Dockets Nos. 50-266
and 50-301

The Commission has issued the enclosed Amendments Nos. 32 and 36 to Facility Operating Licenses Nos. DPR-24 and DPR-27 for the Point Beach Nuclear Plant, Units Nos. 1 and 2. The amendments consist of changes to the Technical Specifications and are in accordance with your application dated July 28, 1977 as revised by letters dated October 5 and December 12, 1977.

POINT BEACH NUCLEAR PLANT, UNIT NO. 1

Amendment No. 32
License No. DPR-24

Figure 15.6.2-4

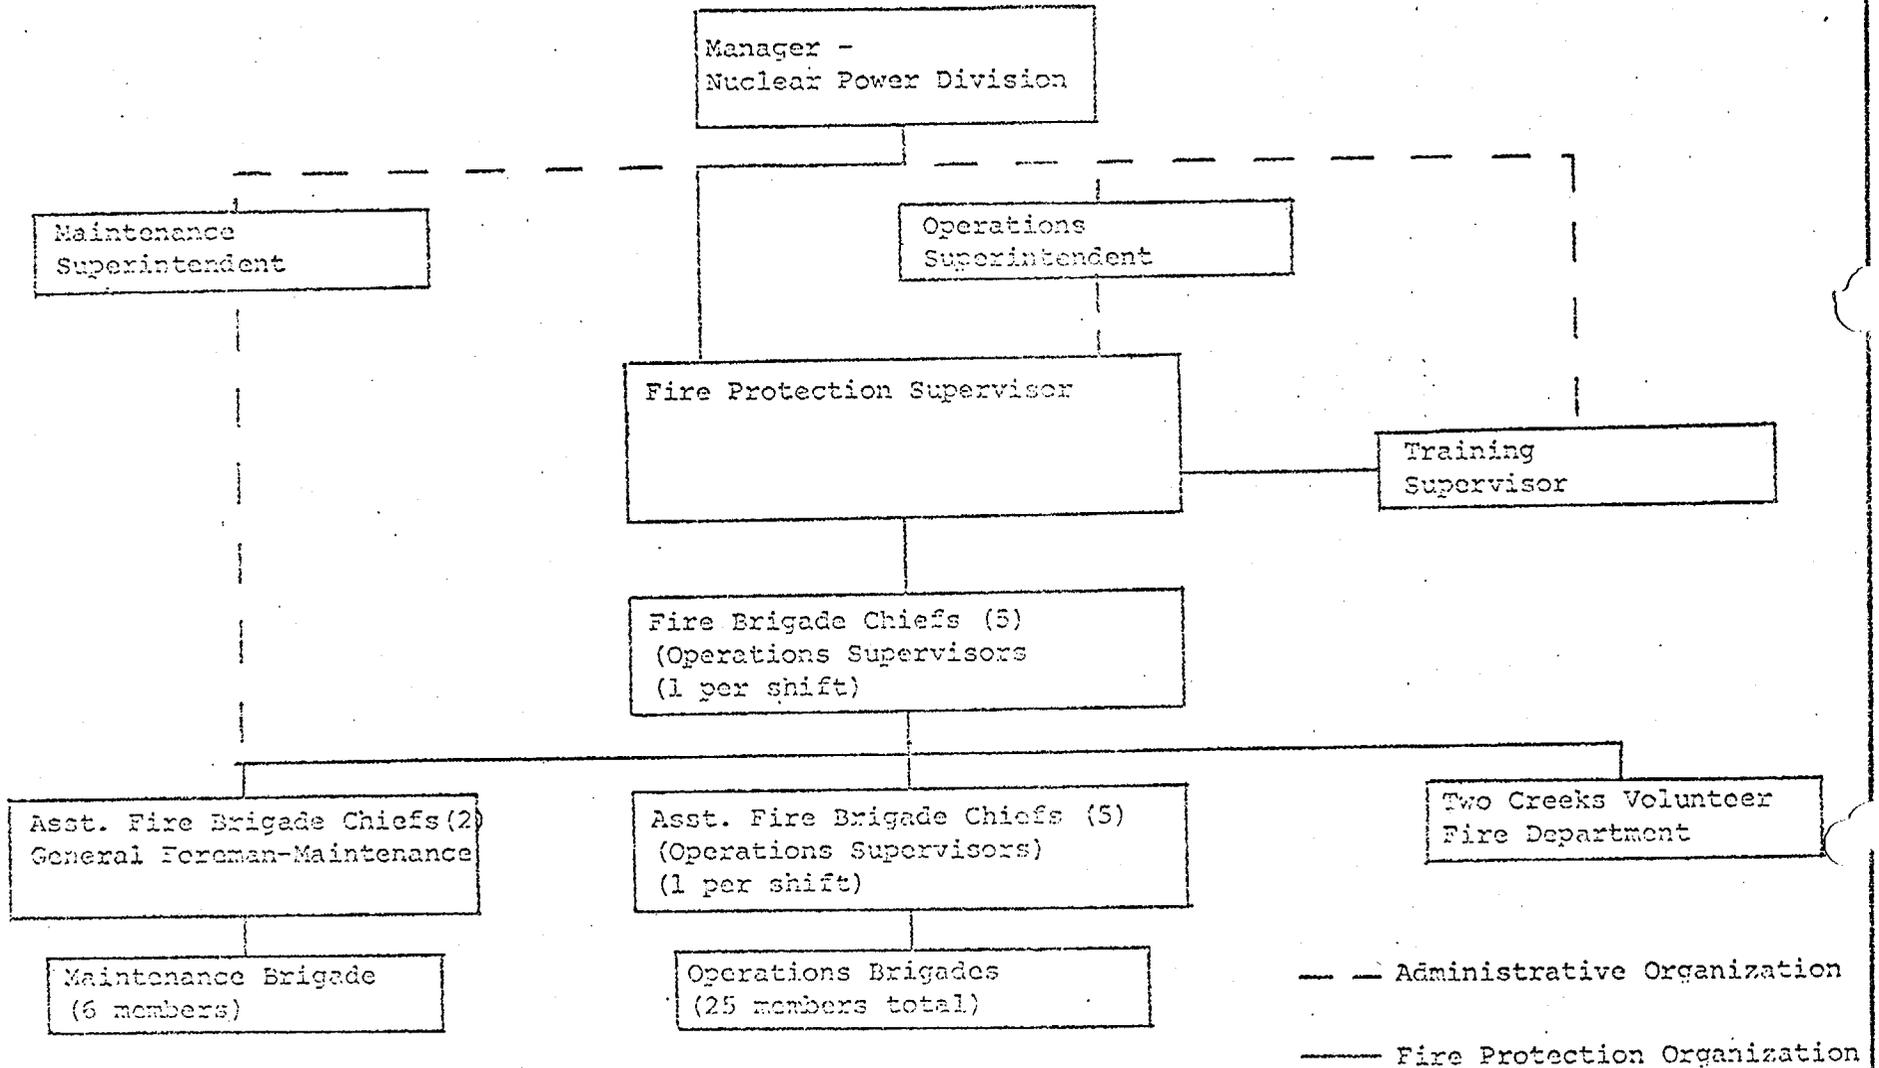
These amendments revise: (1) Specification 15.6.4.2 to reflect the title change of the Fire Protection Supervisor (the title had been Fire Protection Program Manager), (2) Figure 15.6.2-4 to indicate the Fire Protection Supervisor is no longer the Assistant to the Operations Superintendent, and (3) Specification 15.6.8.1.8 to clarify when the fire protection procedures must be provided (as agreed to by the licensee). Since these revisions are administrative matters, the staff finds them acceptable.
